UNITED STATES ENVIRONMENTAL PROTECTION AGENCY
REGION 5
230 SOUTH DEARBORN ST.
CHICAGO, ILLINOIS 60604

August 15, 1990

Enclosed is a copy of the comments for Moss-American. As we discussed today, the pre-negotiation meeting will be held August 27, 1990 in Milwaukee, tentatively at 1 p.m. at the offices of DNR. EPA plans to visit the site before the meeting.

The U.S. Environmental Protection Agency ("EPA") has requested comment on the Remedial Investigation ("RI"), Feasibility Study ("FS"), and Proposed Remedial Action Plan ("Proposed RAP") relating to the Moss-American Site in Milwaukee, Wisconsin. These comments are submitted by Kerr-McGee Chemical Corporation ("Kerr-McGee") in response to EPA's request. They supplement the comments that have been prepared and submitted on behalf of Kerr-McGee by Roy F. Weston, Inc. ("Weston").

Figure 1

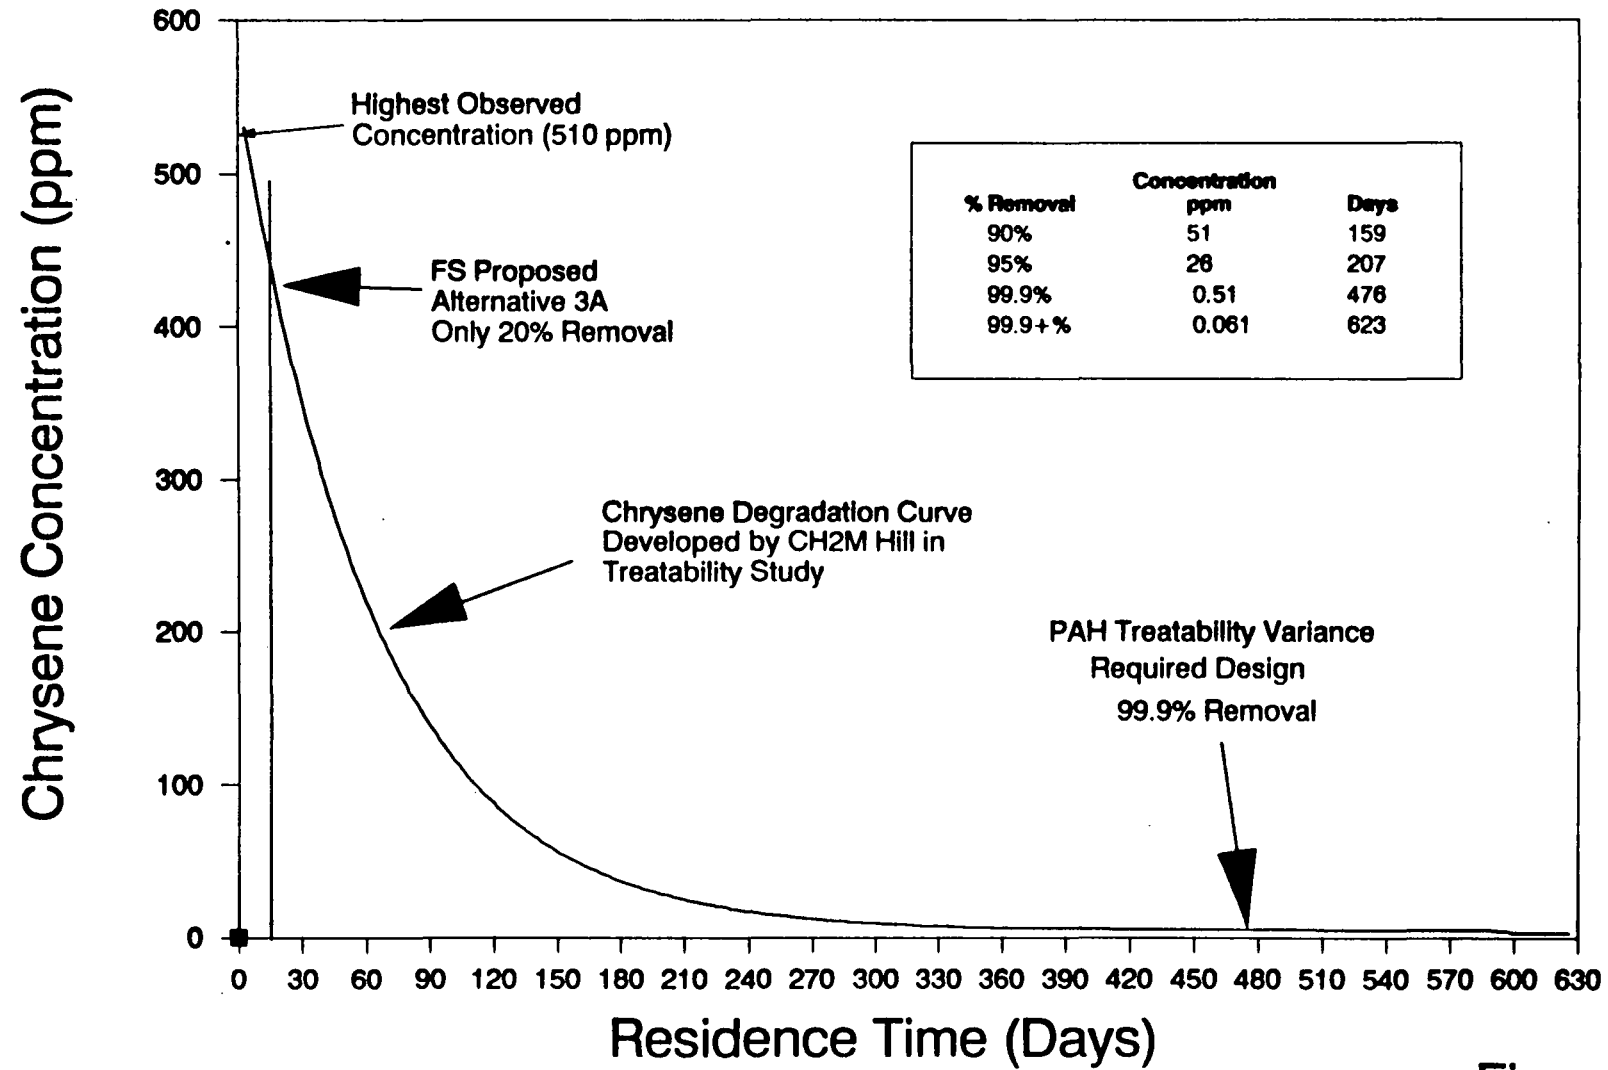
The 15-day residence time proposed in FS Alternative 3A for slurry bioreactor processing only allows for 20% removal of the target carcinogenic PAH, chrysene. The FS's contention that a 15-day residence time is sufficient to provide for 95% removal of target carcinogenic PAHs is unsupported by the FS's own treatability study and is also unsupported by any peer reviewed study described in the available literature. The peer reviewed literature does, however, generally support the test data reported in the FS's treatability study. The chrysene degradation curve shown in Figure 1, and developed in the FS, Appendix K, shows how the proposed 15-day residence time is unrelated to the facts.

The peer reviewed literature does not support the extrapolation of the treatability study data to 99.9% degradation, or reduction to 0.5ppm, of the 5 & 6-ring carcinogenic PAHs as required by the PAH Treatability Variance (see Figure 1). Rather, the literature demonstrates that the biological degradation will cease at concentrations well in excess of those required by the PAH Treatability Variance. The Kerr-McGee Technology Division concurs with the information in the literature and believes that the PAH Treatability Variance clean up criteria cannot be achieved through the slurry bioreactor process for 5 & 6-ring carcinogenic PAHs.

However, for the purposes of this engineering evaluation, the Kerr-McGee Technology Division assumed that improvements in slurry bioreactor processing were available that would enable achievement of the clean up criteria. As shown by Figure 1, the FS's treatability study data demonstrate that a residence time of from 159 to 623 days in the bioreactor will be required to achieve the criteria. Such long residence times necessitate either a very large slurry bioreactor system to accomplish the clean up in 4 to 5 years, or a very long clean up time using several small bioreactors. Since the US-EPA selected an alternative which provided clean up within 3 to 4 years, Kerr-McGee's Technology Division elected to engineer the slurry bioreactor process to accomplish the clean up objectives within the shortest practical time frame (3 years for 90% to 95% degradation and 5 years for 99.9% or greater degradation).

FIGURE 3-12
ALTERNATIVE 3A - SLURRY TREATMENT OF
SOIL AND SEDIMENT AND TREATMENT
OF GROUNDWATER
MOSS-AMERICAN FS

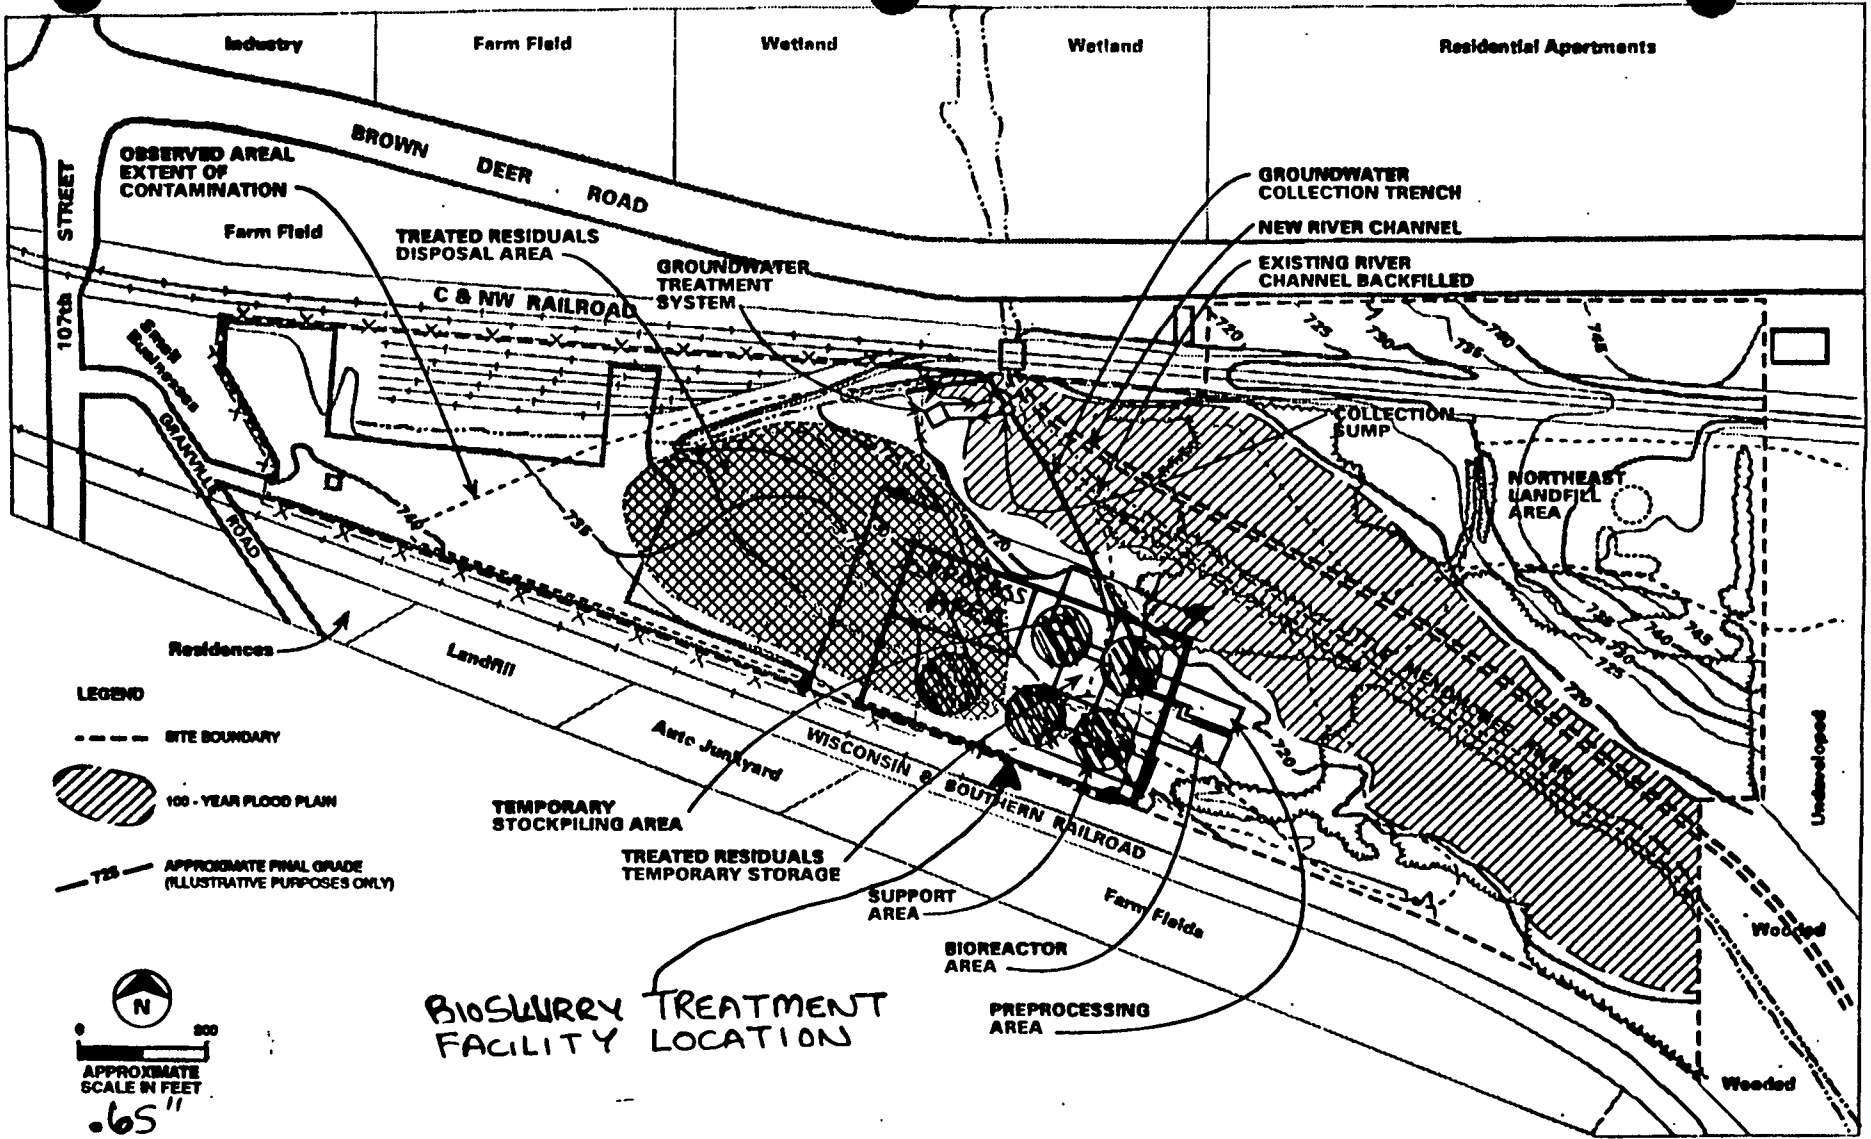
- 8) In terms of the implementability of the preferred remedial alternative, the Agency gave no consideration to interference with ongoing CNW operations or impact on protected wetlands. Further, if Figure 3-12 is compared to figures depicting the alleged extent of soil contamination, U.S. EPA has apparently postulated locating various treatment facilities on top of areas the Agency has defined as contaminated. No consideration is given to the coordination of these facts in the FS assessment of alternatives (see for example FS Figure C-1).
